> Nine Mile Point Nuclear Station, Unit 1 Renewed Facility Operating License No. DPR-63

Subject: License Amendment Request - Revision to the Technical Specifications Design

Features Sections to Remove the Nine Mile 3 Nuclear Project, LLC, Designation

Proposed Technical Specifications Markup Pages

> FIGURE 5.1-1 SITE BOUNDARIES NINE MILE POINT – UNIT 1

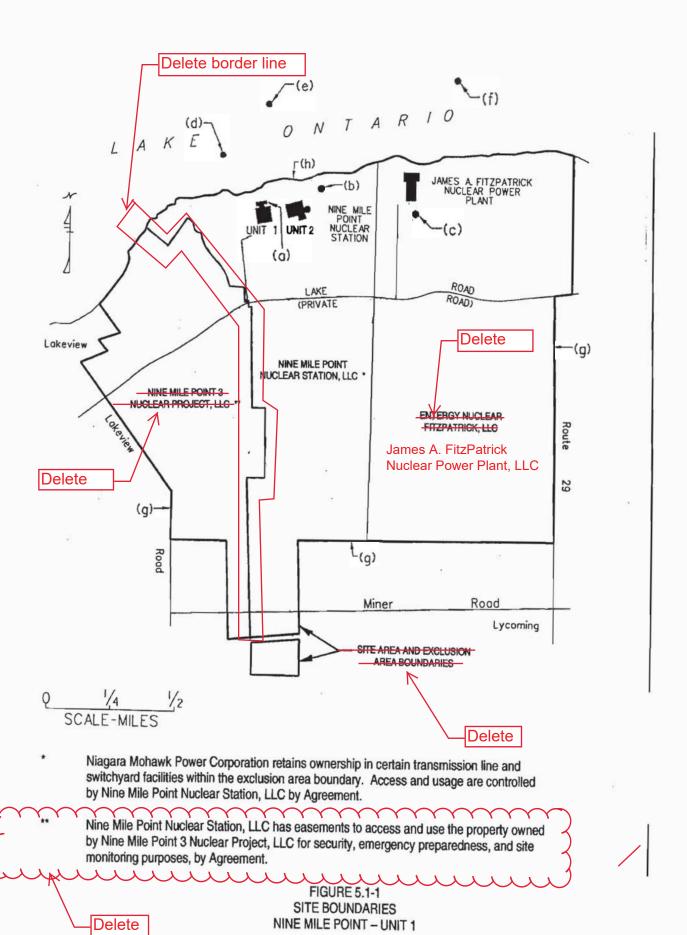
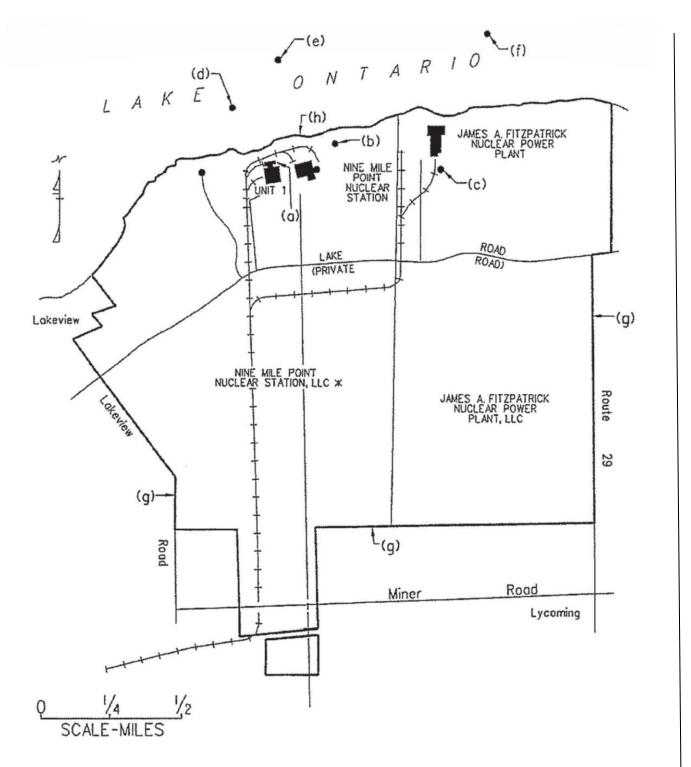
The proposed changes impact the Design Features section of the NMP1 and NMP2 TS and do not require any further technical evaluation. Upon approval of the proposed changes, the NRC can implement the amendments for NMP1 (ML052720229) and NMP2 (ML052720302) TS. This will essentially align the NRC's TS for both units with the current versions of CEG's TS. Specifically, Section 5.0, "Design Features," in the Renewed Facility Operating License DPR-63 for NMP1 and Section 4.0, Design Features," Figure 4.1-1, in the Renewed Facility Operating

Replace with Insert 1

Figure 5.1-1 is a Site Boundary Map of Nine Mile Point which allows the identification of gaseous and liquid waste release points. Figure 5.1-1 also defines the unrestricted area within the site boundary that is accessible (except for fenced areas) to member of the public.

Figure 5.1-1 is a Site Boundary Map of Nine Mile Point which allows the identification of gaseous and liquid waste release points. Figure 5.1-1 also defines the unrestricted area within the site boundary that is accessible (except for fenced areas) to member of the public.

Figure 4.1-1 (Page 1 of 1)
Site Area and Land Portion of Exclusion Area Boundaries

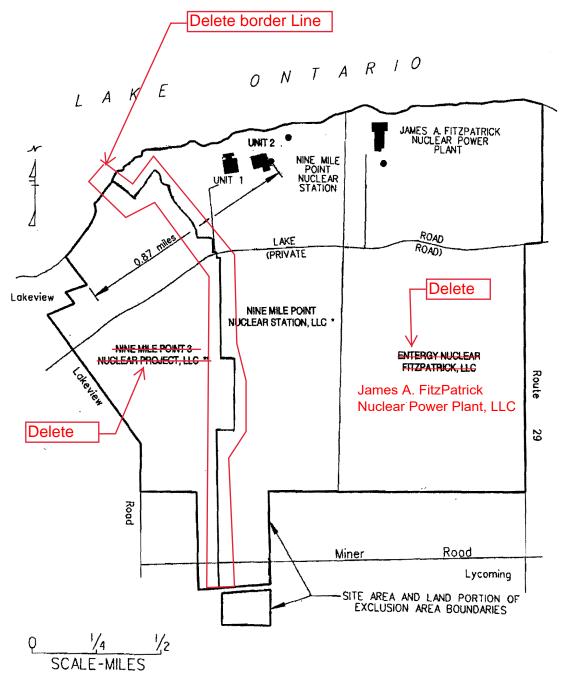
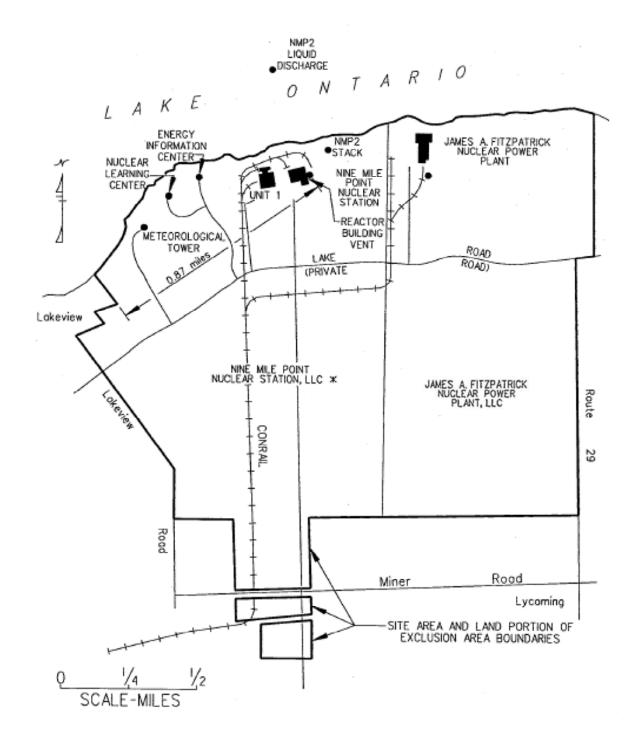
Insert 2

Nine Mile Point Nuclear Station, LLC has easements to access and use the property owned by Nine Mile Point 3 Nuclear Project, LLC for security, emergency preparedness, and site monitoring purposes, by Agreement.

Delete

Niagara Mohawk Power Corporation retains ownership in certain transmission line and switchyard facilities within the exclusion area boundary. Access and usage are controlled by Nine Mile Point Nuclear Station, LLC by Agreement.
